# Access Compliance Report

## Public Rights-of-Way

### (Curb Ramps)

Intersection ID: 10017210	Main Street: HIGHLAND_AV	Cross Street: N/A	Location: SE
ADA ID: 883BFC4F4527	Ramp Type: PerpDiag	Initial Pass/Fail: Fail	Overall Compliance: No
		Severity Score: 60

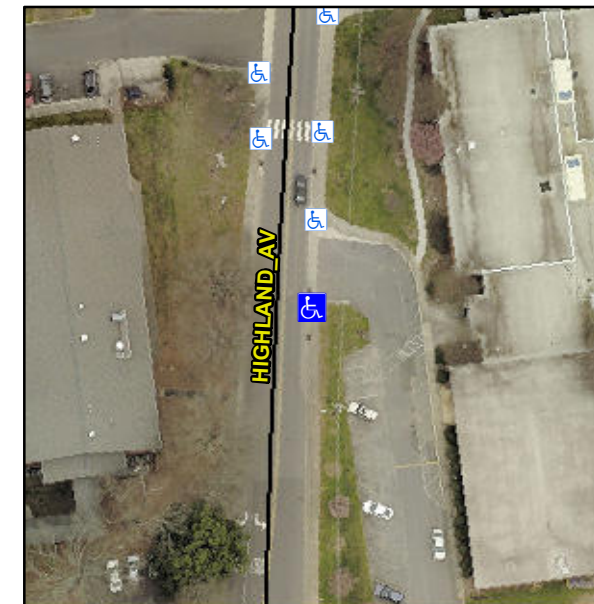
**Not Found, R304.5.1, R304.2.2**

Compliance	Description	Data	Compliance	Description	Data
N/A	Ramp Length (in)	58.0	No	Ramp Slope (%)	12.1
No	Ramp Width (in)	29.0	Yes	Ramp XSlope (%)	0.5
N/A	Flare Type LT	N/A	N/A	Flare Type RT	N/A
N/A	Flare Slope LT (%)	N/A	N/A	Flare Slope RT (%)	N/A
N/A	Flare Traversable LT?	N/A	N/A	Flare Traversable RT?	N/A
N/A	Landing Length (in)	N/A	N/A	DWS Provided?	N/A
N/A	Landing Width (in)	N/A	N/A	DWS Contrast?	N/A
N/A	Landing Slope (%)	N/A	N/A	DWS Length (in)	N/A
N/A	Landing X Slope (%)	N/A	N/A	DWS Full Width?	N/A
N/A	Landing Curb? (Y/N)	N/A	N/A	DWS Offset (in)	N/A
N/A	Shared Landing?	N/A			
N/A	Gutter Ponding?	N/A	N/A	Gutter Slope (%)	N/A
N/A	Gutter Lip Ht (in)	N/A	N/A	Gutter X Slope (%)	N/A
N/A	Painted X Walk1?	No	N/A	Painted X Walk2?	No
	X Walk 1 Direction	To N		X Walk 2 Direction	To W
N/A	X Walk 1 Width (in)	N/A	N/A	X Walk 2 Width (in)	N/A
	X Walk 1 Slope (%)	0.9		X Walk 2 Slope (%)	2.6
	X Walk 1 X Slope (%)	0.3		X Walk 2 X Slope (%)	1.1

**Remove & Replace Curb Ramp With Two New Directional Ramps or Equivalent.**
